CITY OF CANTERBURY BANKSTOWN

STORMWATER SYSTEM REPORT 3 Winston Avenue, BASS HILL NSW 2197

Date: 17-May-2021
Ref: WP-SIA-850/2021
Development type: **Detached Dwelling (single house)**

**100 Year ARI Flood Extent and Flood Contour Levels
(mAHD) from Villawood Catchment
for 3 Winston Avenue, Bass Hill**

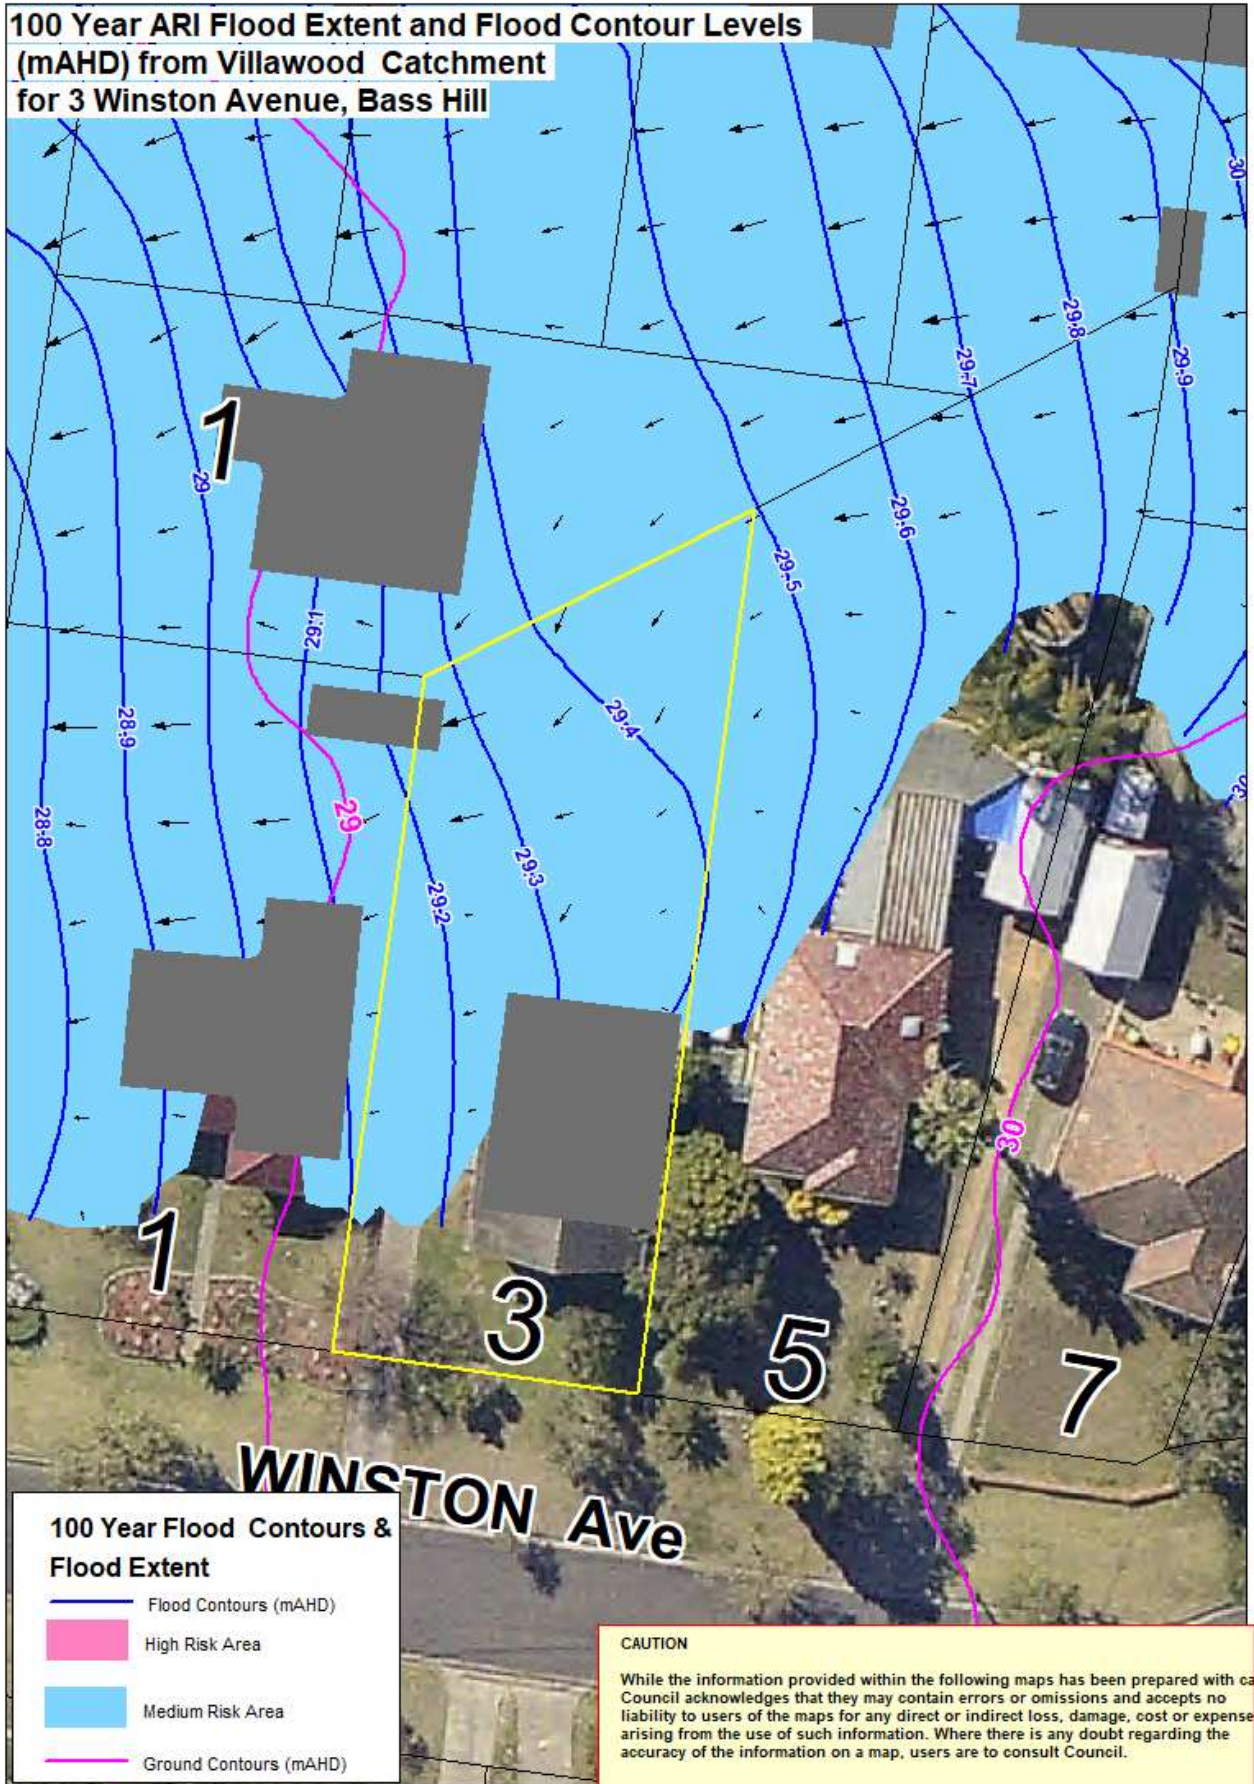
The site will be subject to stormwater inundation from this overland flowpath during large storm events. Refer to the attached "**100 Year ARI Flood Extent Maps from Villawood Catchment Study**" showing the flood contours to m AHD**. Provision should be made on site, and at boundary fences, for this stormwater runoff to pass unobstructed over the site. Stormwater flowing naturally onto the site must not be impeded or diverted.

The estimated 100 year ARI* flood level at the site is RL 29.3 m AHD.**

Habitable floor levels are to be 500mm above the 100 year ARI* flood level at the site adjacent to the proposed buildings.
